RE: HORIZON AT LEE 5 SSD-9827, 45 HONEYSUCKLE DRIVE (LOT 5 DP 1238761)

We are pleased to submit this Section 4.55(1A) application on behalf of Horizon Newcastle Pty Ltd. This application seeks consent for minor design amendments and changes to conditions of consent that have been identified as necessary during the ongoing detailed design in the lead up to the construction certificate phase to the Mixed Use Development approved under SSD-9827.

Figure 1 - Site FSR.

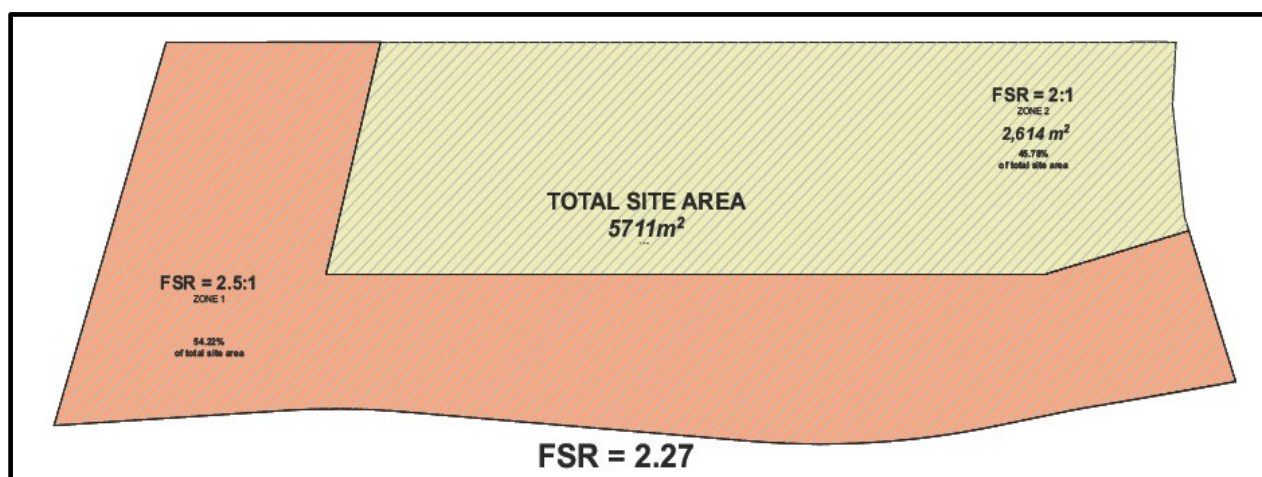
The site is divided into two (2) FSR categories as shown diagrammatically in **Figure 1** below, notated to show the land area calculations for each FSR category.

Based on the area calculations for the FSR categories, under the NLEP controls a total available GFA for the development is 12,970.5m² resulting in a total available FSR of 2.27:1. As referenced above a total building GFA of 14,314m² is proposed, equating to a proposed FSR of 2.51:1 resulting in an overall variation of approximately 10.3%.

SOUTH ELEVATION
SCALE 1:200 @ A1

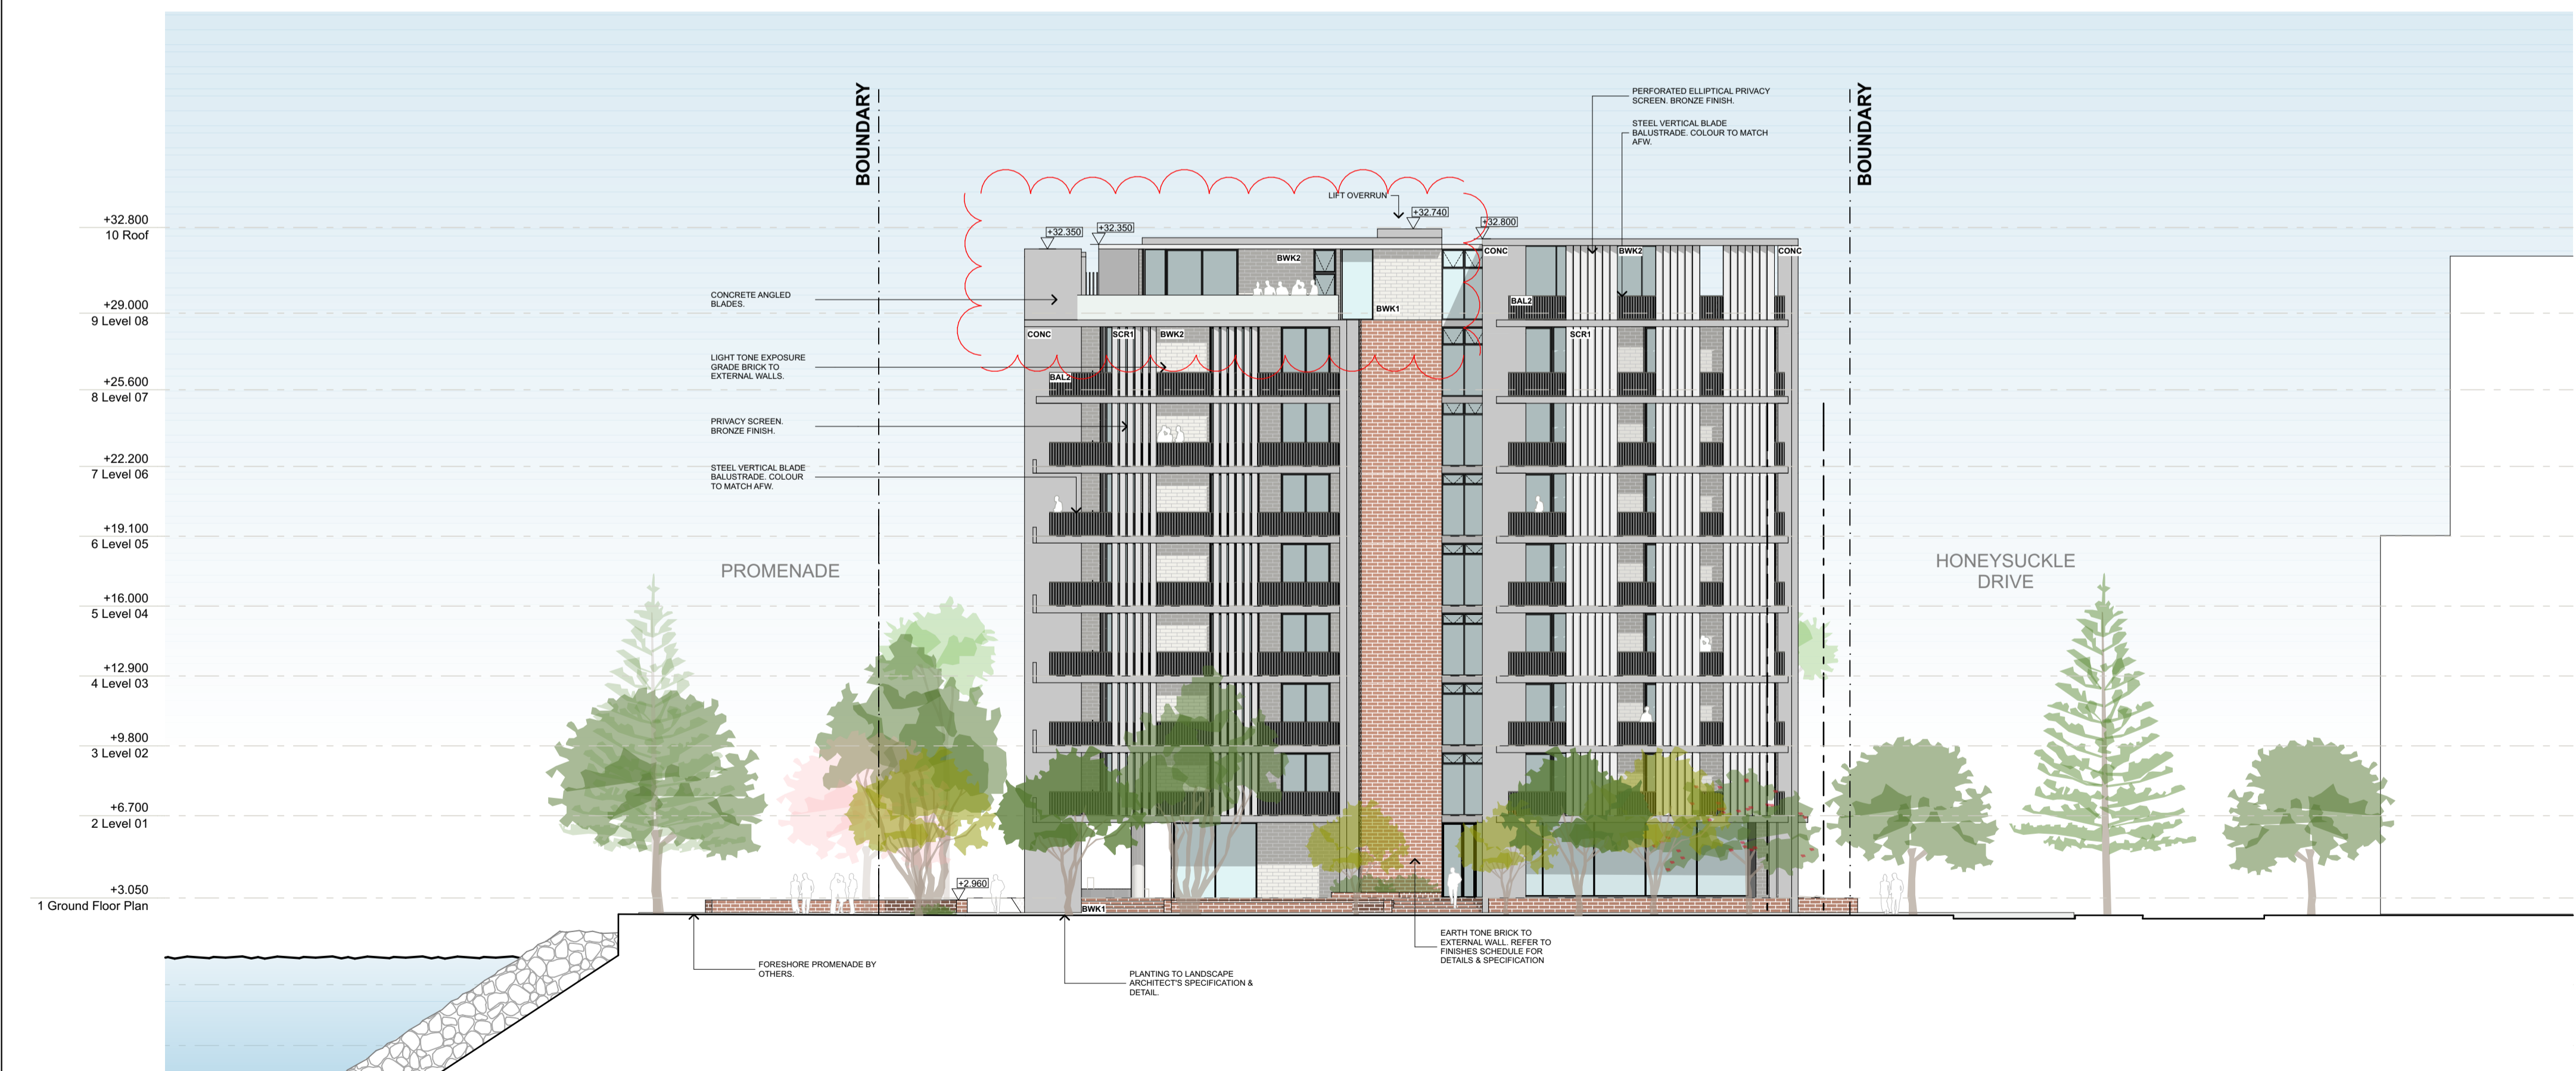
- As described above, the void in the centre of the middle building on the southern elevation between Units M5 and M6 has been filled as a result of a design rationalisation to the buildings core. This will see result in a slight increase to the area of the balconies for the 2 Bed Units on Levels 1 to 6 and provide a reinforced building entrance.
- Amendments to the western and eastern elevations to each of the three buildings as a result of the minor changes to the penthouse units.
